<b>Technical Service Bulletin:</b> TSB190085	<b>Released Date:</b> 21-May-2019
<b>Bosch® VE, VP-14 or VP-30 ReCon Fuel Pump Kit Update</b>

## Bosch® VE, VP-14 or VP-30 ReCon Fuel Pump Kit Update

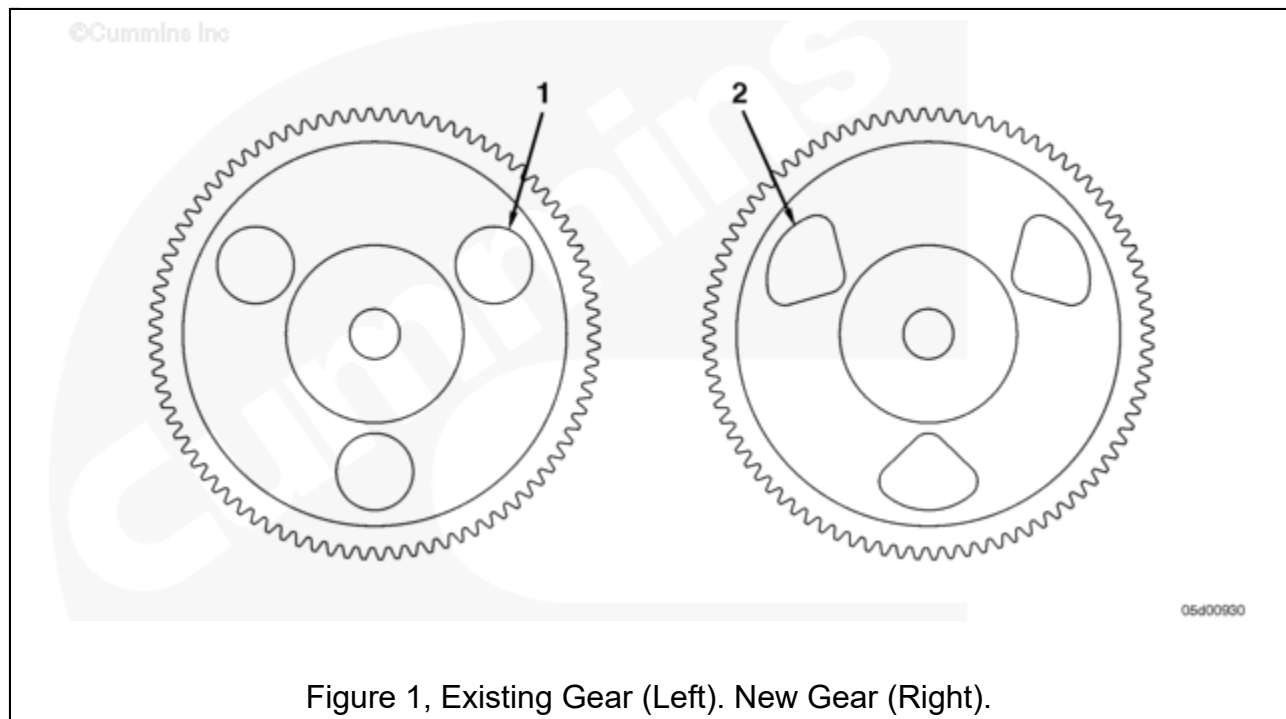
Existing fuel pump gear, Part Number 3936021, has been obsoleted and superseded by a new redesigned gear, Part Number 4932713.

New fuel pump gear design was changed to extend 3 mm into center hub of part number

4932713 to allow the gear to contact the driveshaft away from machined keyway.

Web holes on new fuel pump gear have been changed to help distinguish between existing and new gears. See Figure 1 below.

An inspection during troubleshooting reveals that fuel pump driveshaft is fractured at end of keyway toward the fuel pump housing. This malfunction can occur due to fuel pump gear design that creates a high stress point on the back of the keyway on the pump driveshaft where the fuel pump gear and/or gear housing can become damaged.

1. Existing gear, Part Number 3936021

- Round hole shape

2. New gear, Part Number 4932713

- Triangular hole shape
